Porsche Carrera Cup Deutschland 2022

Bulletin 03/2022

The amendment is valid with immediate effect.

Attachment 11 – Alternative Z-Clamp Mounting is supplemented as follows:

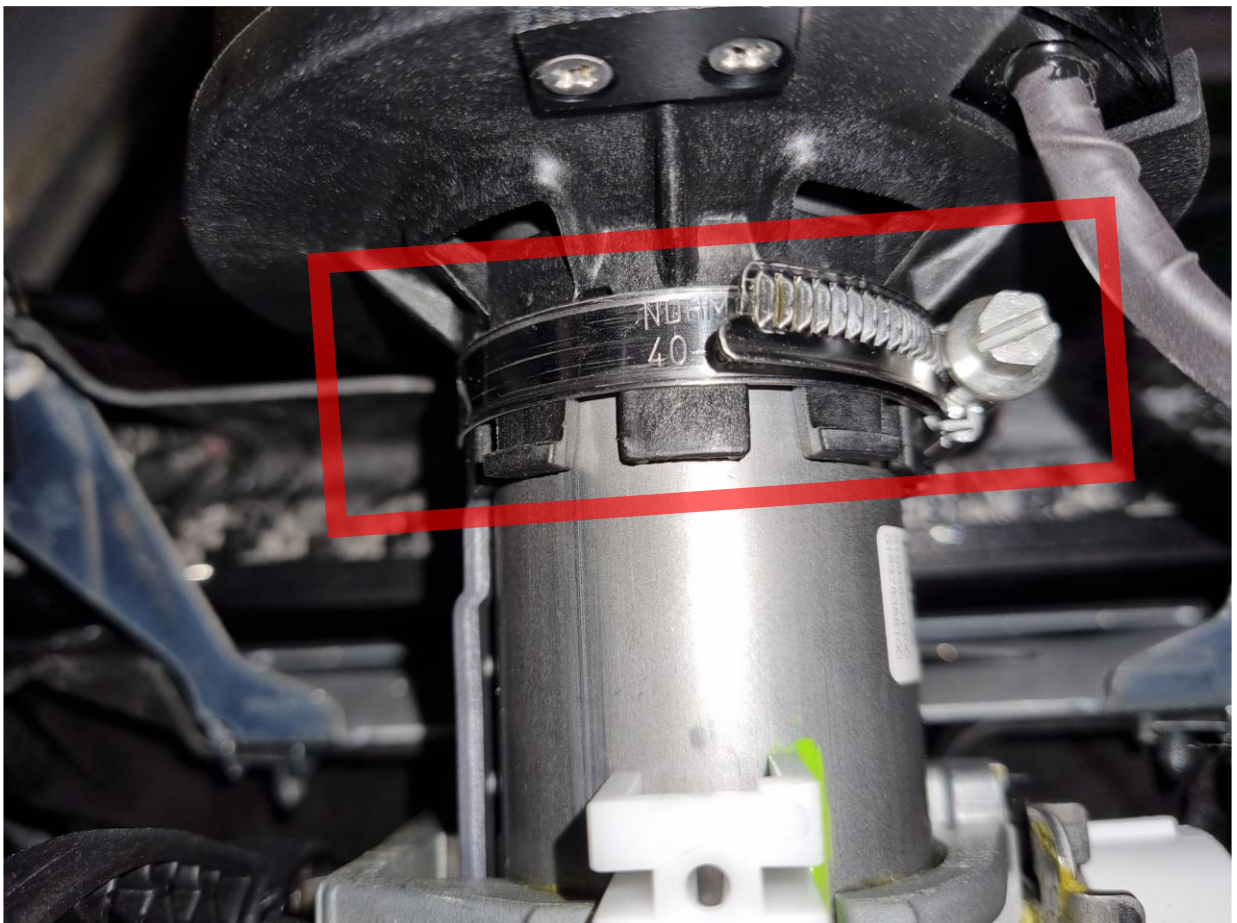
An alternative mounting ring may be used instead of the Z Clamp Fitting (part number 9F1253543A). However, it must be ensured that the alternative clamp is not colliding with any of the other parts. The maximum permissible overhang of the alternative clamp is 10mm."
